| Office Action Summary | Application No. 10/787,188 | Applicant(s) TAKATA, YOSHIKI | |

DETAILED ACTION

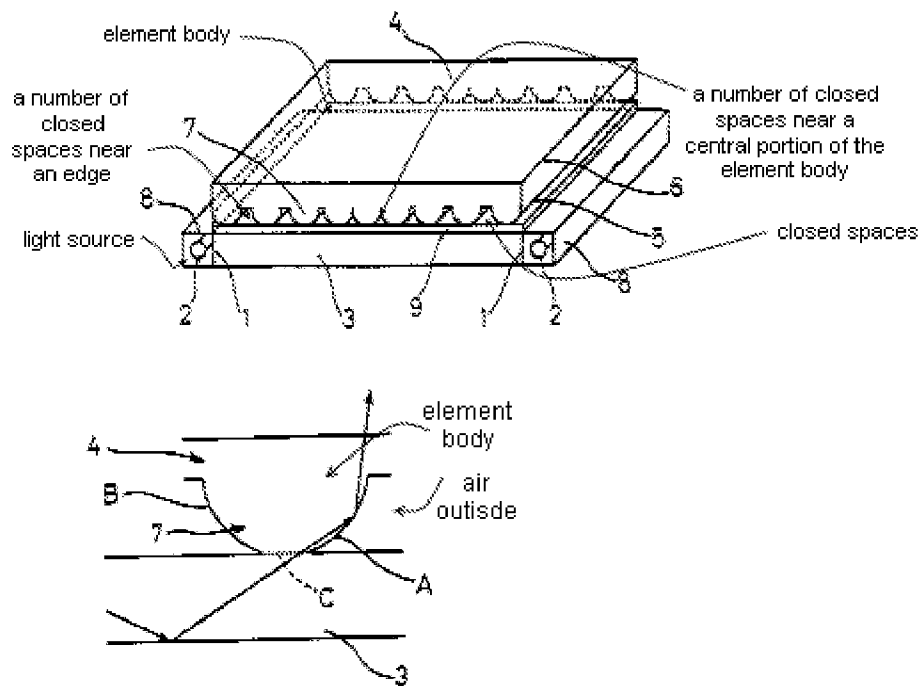
Regarding claims **26 and 32**, Yamashita et al. discloses an element body (e.g., 6 & 8) having a generally plate shape constituted with a material having a larger electric permittivity than air outside the element body (e.g., column 10, lines 40-50) and, in the inside of the element body (e.g., 6 & 8), a plurality of closed spaces (e.g., 3, 4, 50) are disposed whose electric permittivity is smaller than that of the material constituting the element body (e.g., 6 & 8) and whose surfaces opposite to a radiation surface (e.g., Figures 1, 6, 7) are generally flat, the element body (e.g., 6 & 8) comprising a first member (e.g., 6) having a radiation source (e.g., 1) disposed on a side thereof and a second member (e.g., 5) disposed on the radiation surface side (e.g., Figures 1, 6, 7) in close adhesion (e.g., Figures 14-15) with the first member (e.g., 6), the closed spaces (e.g., 3, 4) being formed in the first member (e.g., 6) and in the second member (e.g., 5).

Regarding claims 27 and 33, Yamashita et al. discloses at least some of the closed spaces in the first member (e.g., 6) are aligned with at least some of the closed spaces in the second member (e.g., Figure 1).

Regarding claims 28 and 34, Yamashita et al. discloses at least some of the closed spaces (e.g., 3, 4) in the second member partially overlap at least some of the closed spaces in the first member (e.g., Figure 20).

Regarding claims 29 and 35, Yamashita et al. discloses at least some of the closed spaces in the second member are offset from all closed spaces in the first member (e.g., Figure 20).

Regarding claims 30 and 36, Yamashita et al. discloses a plurality of the closed spaces include surfaces opposite to the radiation surface that are generally parallel to the radiation surface (e.g., Figures 2-4, 18).

Regarding claims 31 and 37, Yamashita et al. discloses a plurality of the closed spaces include surface opposite to the radiation surface that are generally parallel to each other (e.g., Figures 2-4, 18).

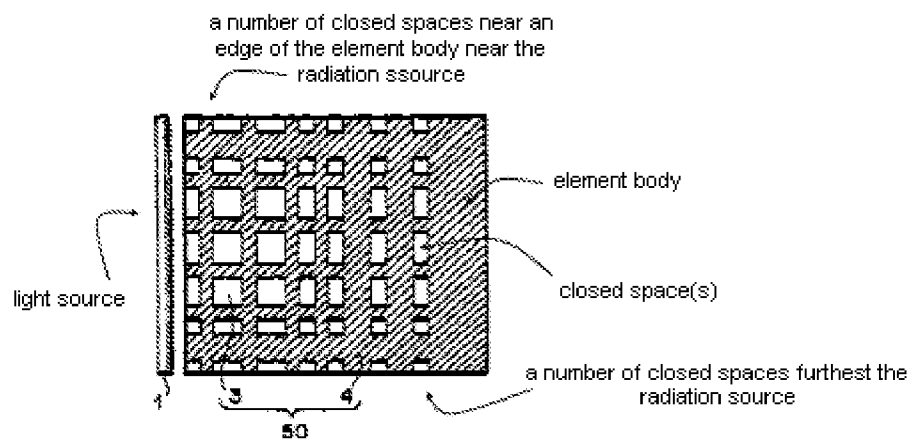
Regarding claims **1** and **8**, Onishi et al. discloses an element body (e.g., 4) has a *generally* plate shape constituted (e.g., Figure 13) with a material having a larger electric permittivity than air outside the element body and, in the inside of the element body, a plurality of *closed spaces* (e.g., see Figure below) are disposed whose electric permittivity is smaller (e.g., air outside) than that of the material constituting the element body and whose surfaces opposite to a radiation surface are *generally* flat, wherein a number of closed spaces near an edge of the element body near the radiation source is lesser than in a central portion of the element body (e.g., column 11, lines 5-35; "... *the arrangement in which some of the projections 7 adjacent each of the light source are distributed loosely while some of the projections 7 at a location generally intermediate between the light source are distributed densely is effective to provide a pattern of uniform distribution of luminance*").

Onishi et al. failed to specify the number of closed spaces near an edge being greater than a central portion of the element body.

However, it would have been obvious to one having ordinary skill in the art at the time the invention was made to utilize differently shaped projections (e.g., Figures 2A-4D; column 7, lines 25-55; "... the present invention have conducted extensive studies of various light output plates each having the projections 7 of different shape to determine the right shape for the projections 7 in terms of the maximized luminance exhibited by the planar light source device") that may require different arrangements (e.g., column 11, lines 5-35; "... the arrangement in which some of the projections 7 adjacent each of the light source are distributed loosely while some of the projections 7 at a location generally intermediate between the light source are distributed densely is effective to provide a pattern of uniform distribution of luminance") through the element body to maximize the luminance exhibited by the planar light source device, as

alternatively suggested by Onishi et al. The modification of rearranging more closed spaces near the edge is desirable providing an alternative ways to maximize the luminance of the over all LCD device, since it has been held that rearranging parts of an invention involves only routine skill in the art. *In re Japikse*, 86 USPQ 70.

Regarding claims 2 & 9, Onishi et al. discloses the claimed invention, explained above. In addition, Onishi et al. discloses a plurality of *closed spaces* is disposed whose surfaces opposite to the radiation surface are generally parallel to the radiation surface (e.g., Figure 9).

Regarding claims 3 & 10, Onishi et al. discloses the claimed invention, explained above. In addition, Onishi et al. discloses a plurality of *closed spaces* is adjacently disposed whose surfaces opposite to the radiation surface are generally parallel to each other (e.g., Figure 9).

Regarding claims 4 & 11, Onishi et al. discloses the claimed invention, explained above. In addition, Onishi et al. discloses a first member having a radiation source (e.g., 2) disposed on a side thereof and a second member disposed on the radiation surface side are constituted to be in close adhesion (e.g., column 5, lines 15-30), and the closed spaces are formed between the first member and the second member.

Regarding claims 5 & 12, Onishi et al. discloses the claimed invention, explained above. In addition, Onishi et al. discloses at least one member of the first member (e.g., 3) and the second member (e.g., 7) has recesses formed therein, and the recesses

(e.g., A) are disposed to constitute the closed spaces by joining the first member and the second member.

Regarding claims 6 & 13, Onishi et al. discloses the claimed invention, explained above. In addition, Onishi et al. discloses a total reflection-restraining layer such as a scatter layer is disposed in the radiation surface (e.g., claims 28-30).

Regarding claims 7 & 14, Onishi et al. discloses the claimed invention, explained above. In addition, Onishi et al. discloses the closed spaces are filled with solid layers having a smaller electric permittivity than the material constituting the element body.

Regarding claims **16-18** and **20-22**, Onishi et al. discloses the structural limitations of the applicant's claimed invention, explained in above paragraphs.

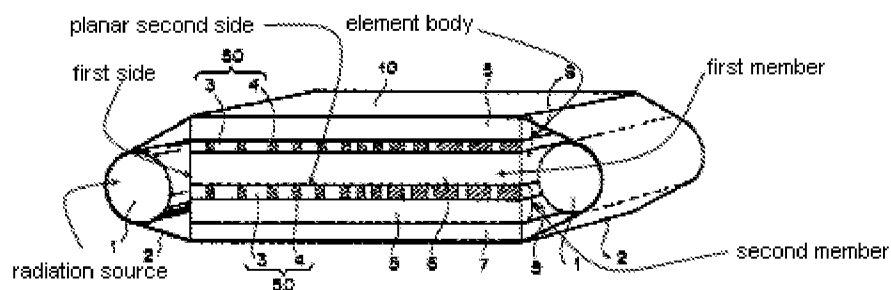
Regarding claims **1** and **8**, Yamashita et al. discloses an element body (e.g., 6 & 8) has a generally plate shape (e.g., Figure 3) constituted with a material having a larger

electric permittivity than air outside the element body (e.g., column 10, lines 40-50; "... a composite layer 50 constituted of a low refractive index region (first refractive index region) 3 of a refractive index $n1$ and a high refractive index region of a refractive index $n2$ (second refractive index region) 4") and, in the inside of the element body (e.g., 6 & 8), a plurality of closed spaces (e.g., Figures 1-20) are disposed whose electric permittivity is smaller than that of the material constituting the element body and whose surfaces opposite to a radiation surface are *generally* flat (e.g., Figure 1, 5, 6, 7), wherein a number of closed spaces (e.g., 3, 4, 50) near an edge of the element body near the radiation source is greater than in a furthest portion of the element body (e.g., Figure 3).

Yamashita et al. fails to specifically show the two elongated light sources positioned opposite one another, where the number of closed spaces near an edge of the element body is greater than in center portion of the element body.

However, it would have been obvious to one having ordinary skill in the art at the time the invention was made to implement teachings of Yamashita et al. (e.g., Figure 3, columns 10-12, lines 60-45; "... low refractive index region 3 and the high refractive

Regarding claims 2 & 9, Yamashita et al. discloses the claimed invention, explained above. In addition, Yamashita et al. discusses a plurality of *closed spaces* are disposed whose surfaces opposite to the radiation surface are *generally* parallel to the radiation surface (e.g., Figures 2-4).

Regarding claims 3 & 10, Yamashita et al. discloses the claimed invention, explained above. In addition, Yamashita et al. discloses a plurality of *closed spaces* is adjacently disposed whose surfaces opposite to the radiation surface are generally parallel to each other (e.g., Figures 2-3).

Regarding claims 4 & 11, Yamashita et al. discloses the claimed invention, explained above. In addition, Yamashita et al. discloses a first member having a radiation source (e.g., 1) disposed on a side thereof and a second member disposed on the radiation surface side are constituted to be in close adhesion (e.g., columns 4-8, lines 25-25), and the closed spaces are formed between the first member and the second member.

Regarding claims 5 & 12, Yamashita et al. discloses the claimed invention, explained above. In addition, Yamashita et al. discloses at least one member of the first member (e.g., 6) and the second member (e.g., 50 and/or 5) has recesses formed therein, and the recesses (e.g., 3, 4,) are disposed to constitute the closed spaces by joining the first member (e.g., 6) and the second member (e.g., 50 and/or 5).

Regarding claims 6 & 13, Yamashita et al. discloses the claimed invention, explained above. In addition, Yamashita et al. discloses a total reflection-restraining layer such as a scatter layer is disposed in the radiation surface (e.g., 8, 10).
